Figure 17: Indicative montage of the garden plaza (source: EA).

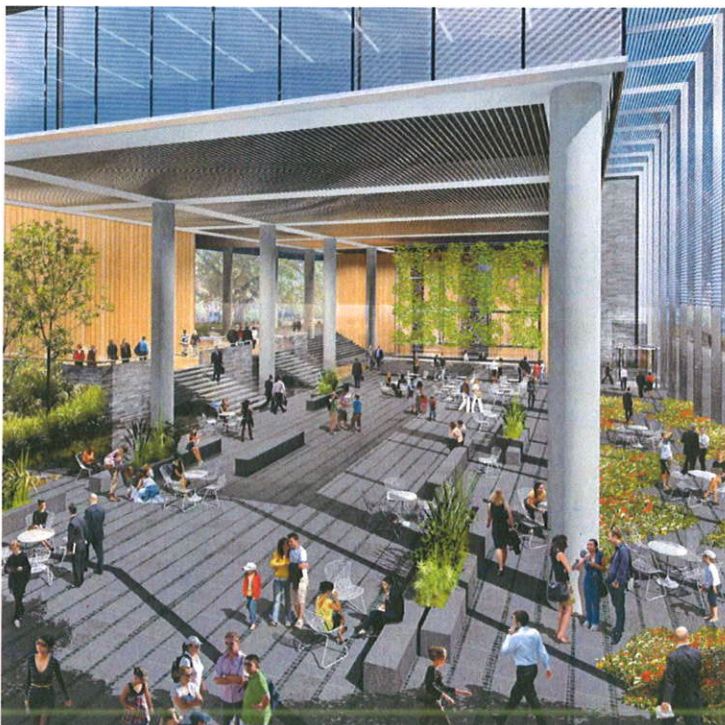
Although the proposal has merit in terms of offering an all-weather alternative to the outdoor Special Areas, it is noted that the outdoor areas are accessible outside of weekday business hours, whilst the garden plaza would only be accessible between 7:00am and 7:00pm weekdays, with a public easement or similar right of access created over the space.

The plaza has the potential to make a substantial contribution to street activation within the CBD, a public benefit which should not necessarily be restricted to weekdays. The North Sydney CBD is still active on weekends. In this instance, where a degree of public amenity is proposed to be 'substituted' by a plaza on private land, some provision should be made for residents and weekend workers to enjoy the public benefits being offered.

In this regard, it is recommended that a future assessment requirement be included that requires the Proponent to give consideration to the opening of the plaza outside of the proposed range of opening hours to further activate this space.
